# Case No. 16DEVPLAN1021

## Subway Center

**Louisville Metro Board of Zoning Adjustment Public  
Hearing**

**June 6, 2016**

# Applicant's Development Plan

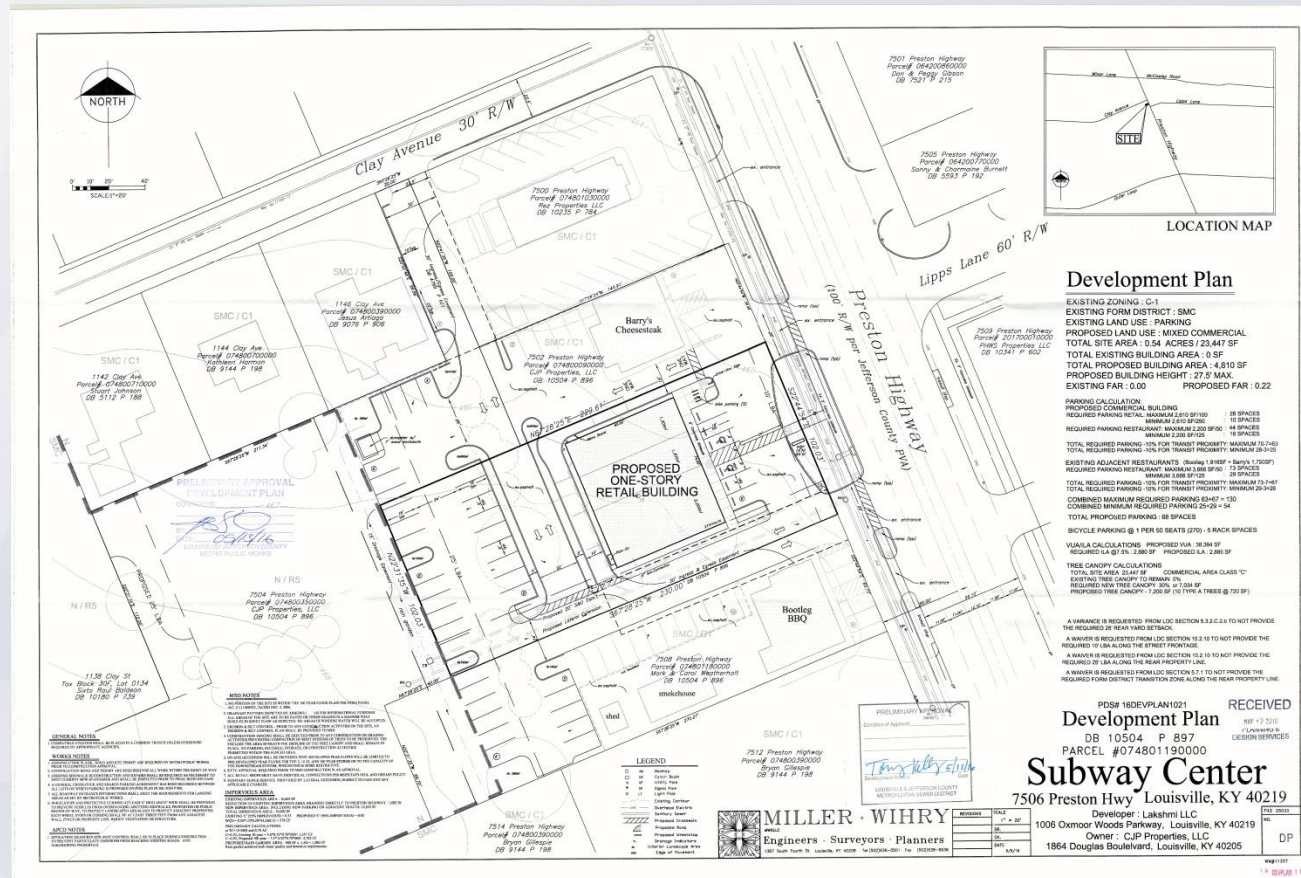
- The standard of review is justified for the variance, and waivers 1 and 3. However, staff finds that the landscape waiver (waiver #2) for the frontage along Preston Highway could be provided as other businesses in the general vicinity have complied with LDC.
